Change Order Request - PR 10 Electriical Changes Revision #2

768-- LFUCG Senior and Therapeutic Center

PROPOSAL REQUEST

Project:	**Lexington STC**	**Proposal Request number:**	**10**
Owner:	**LFUCG**	**Date:**	12/15/2025
		File Number:	PR-10rev2.pdf
To:	**Calhoun Construction Services**

1 FIRST FLOOR SYSTEMS PLAN- AREA B
SCALE: 1/8" = 1'-0"
0 2' 4' 8' 16' 24' 32'

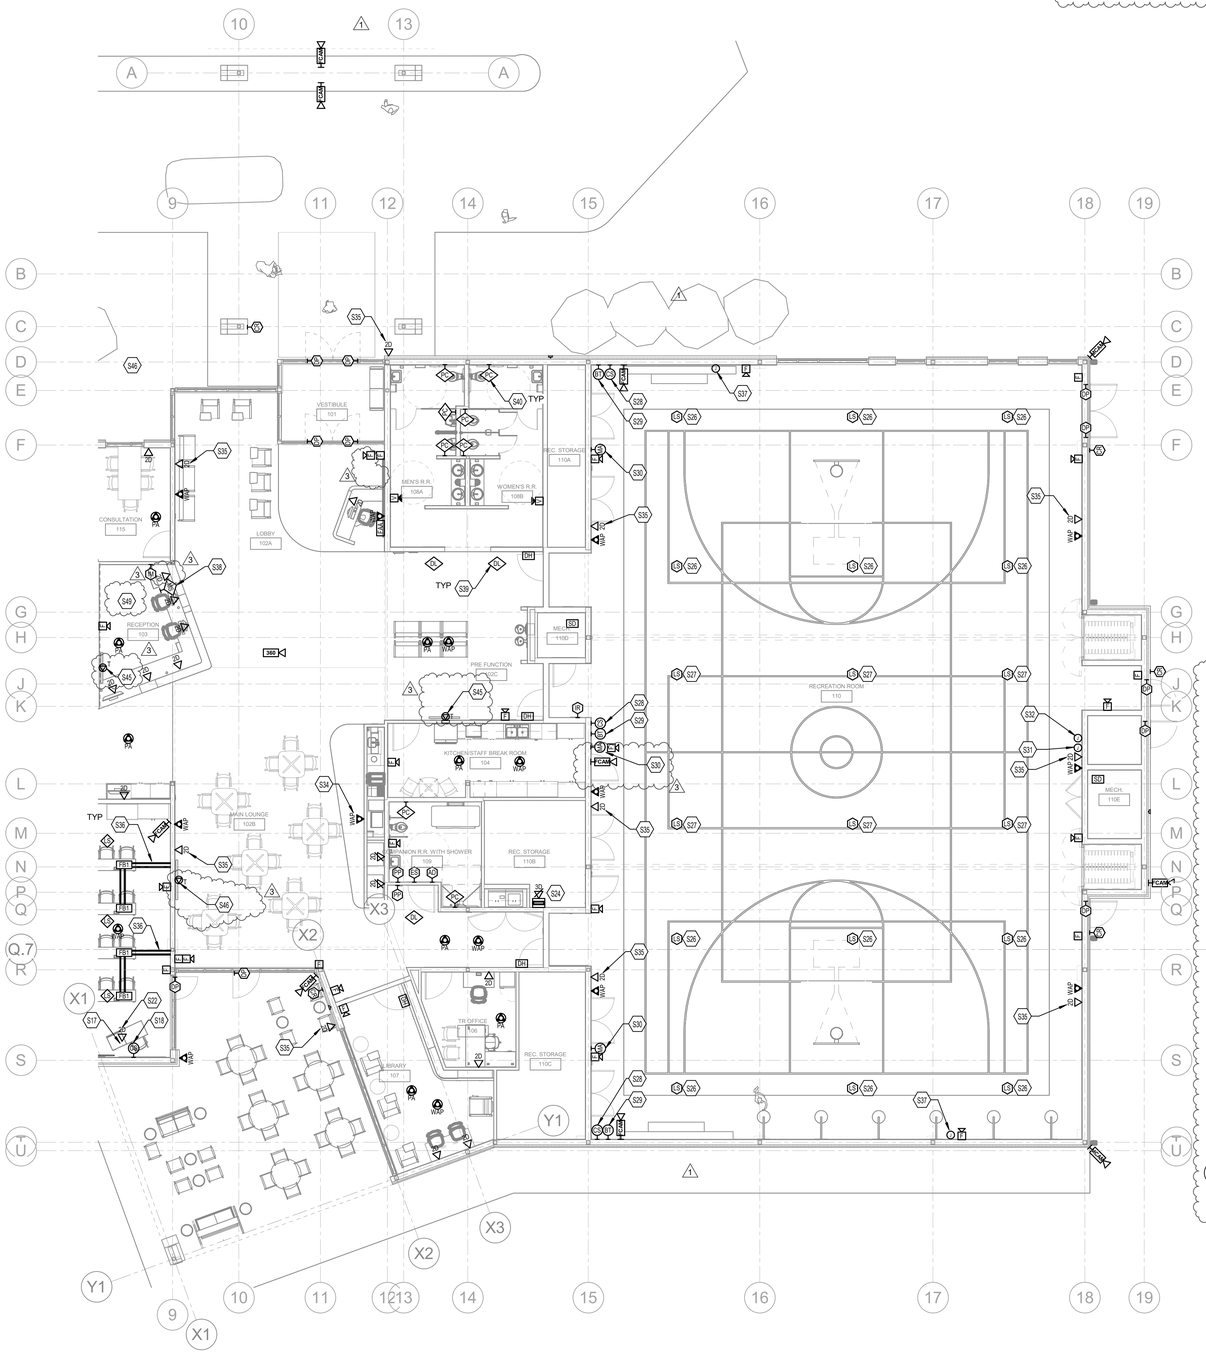
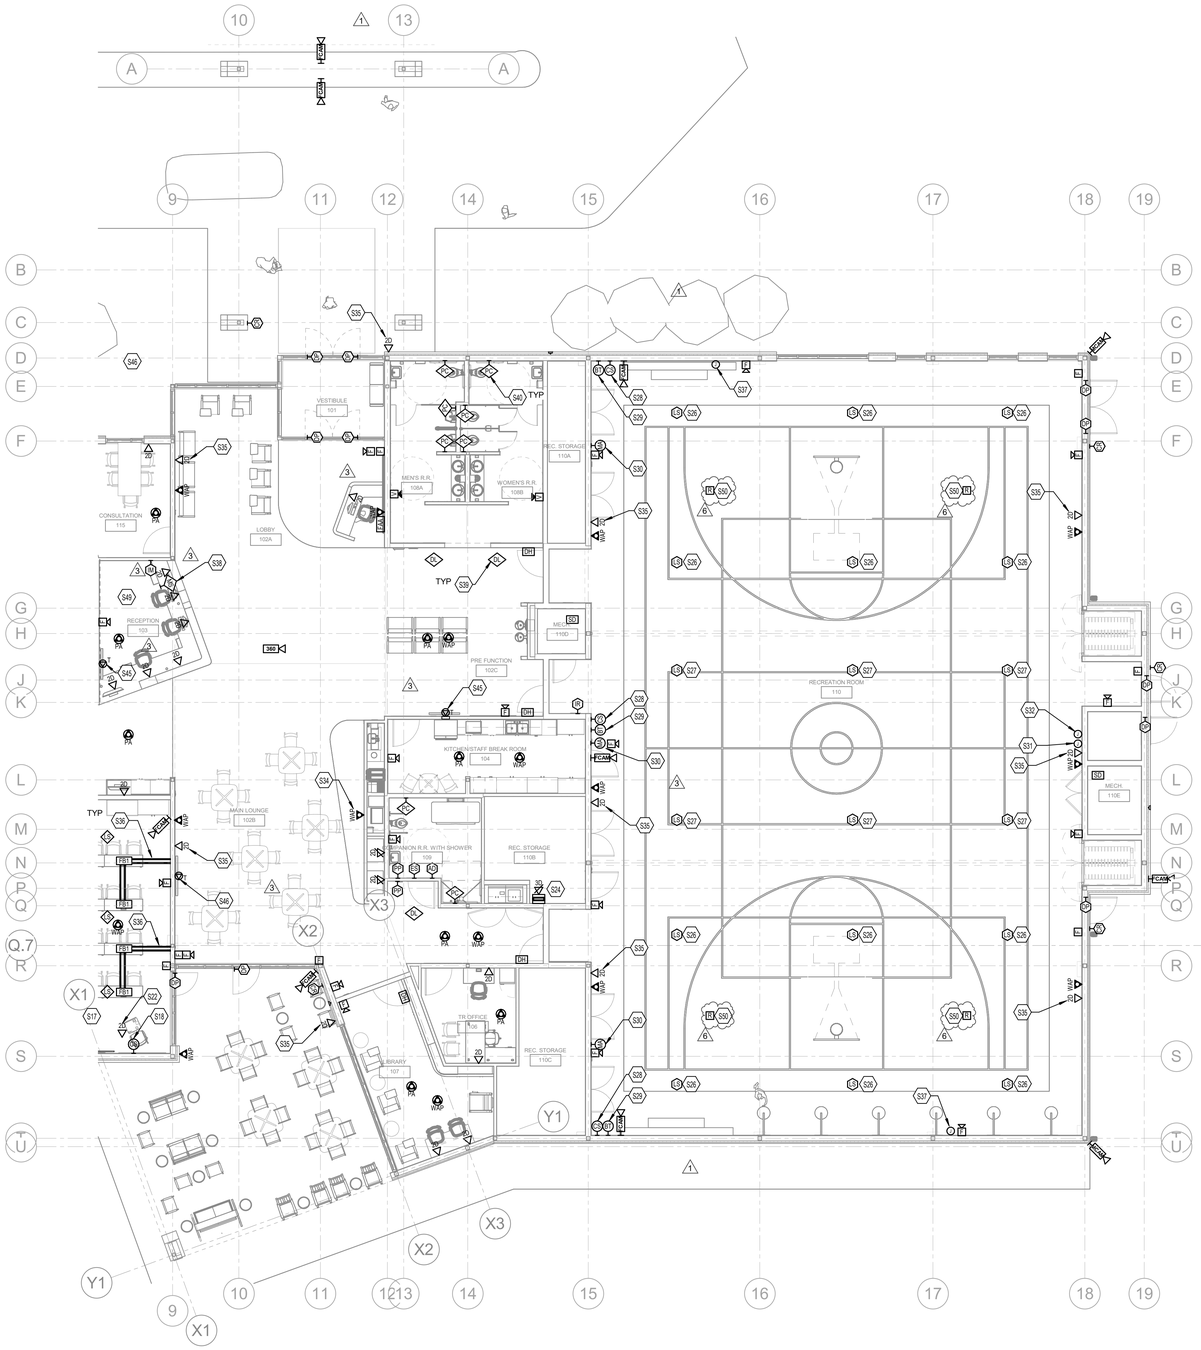
a. Added digital signage information and screen information in main lounge 102B.
b. Added digital signage information and screen information in pre function 102C
c. Added security camera in Recreation Room 110.
d. Shifted Fire Alarm devices to avoid added artwork at lobby 102A by security desk.
e. Added information in floor box schedule
f. Added wall box detail for digital screen locations
g. (RFI #59) Added circuits for ceiling fans.

E-505

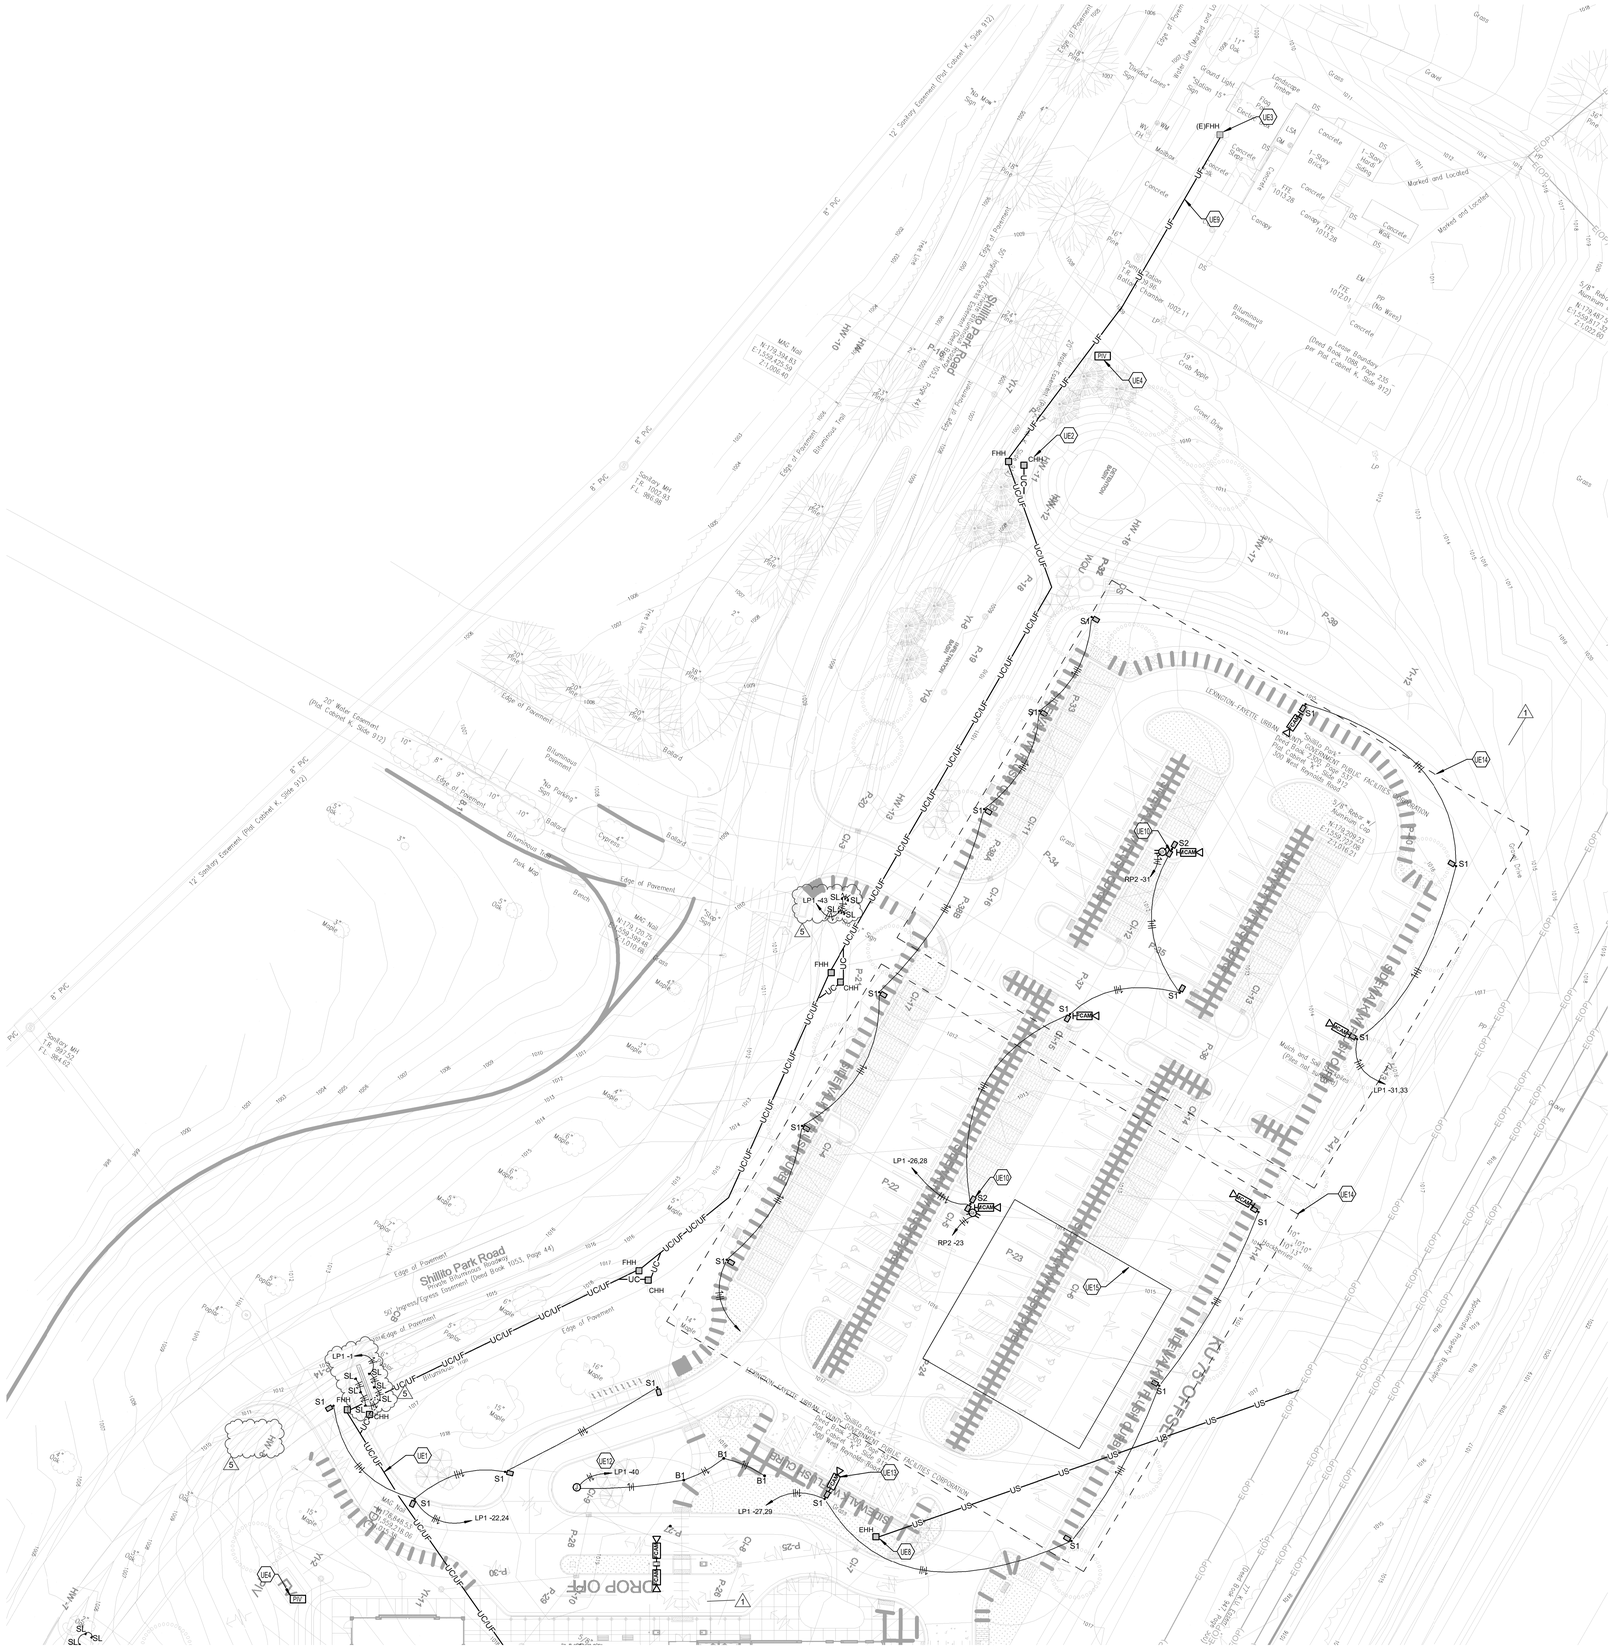
a. Added A/V flow diagram for digital signage configuration setup

2 EAST CRICKET SECTION
ASK-16 SCALE: 3/4" = 1'-0"

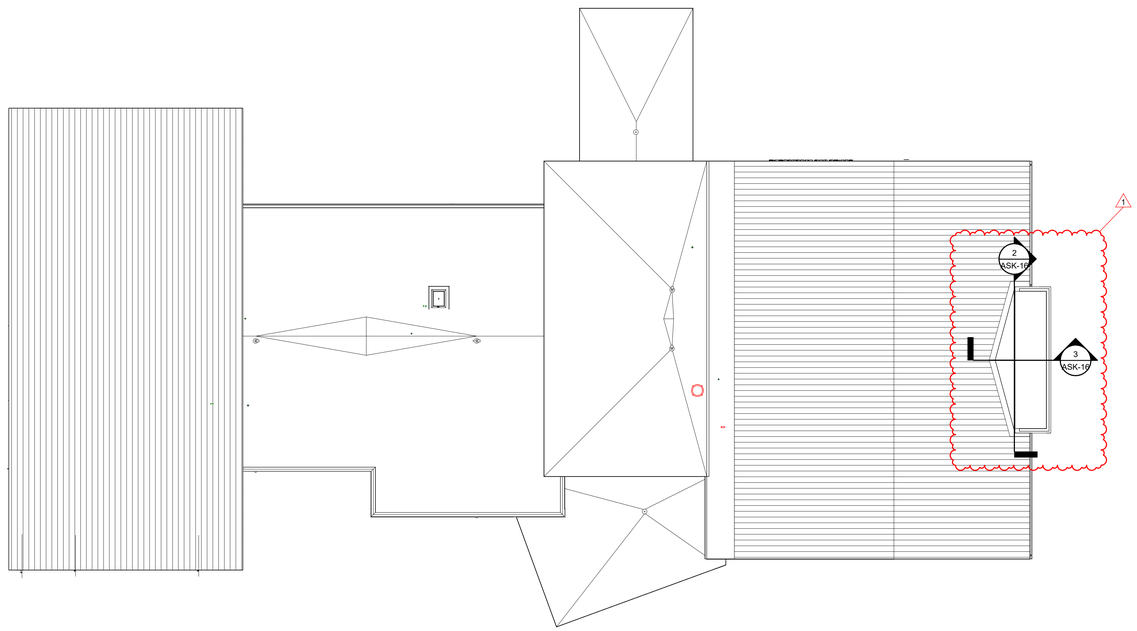
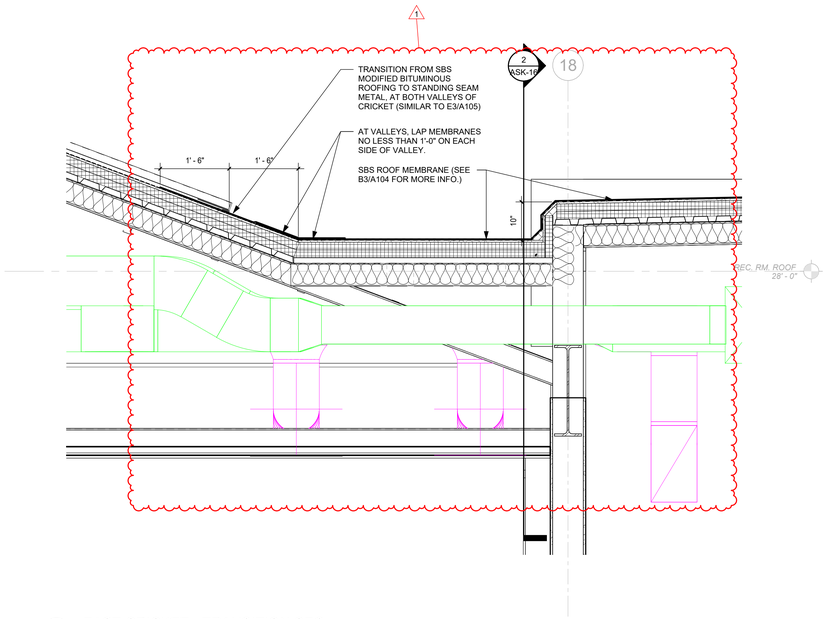
Origination of Change(s): Modification to accommodate earlier structural revisions.
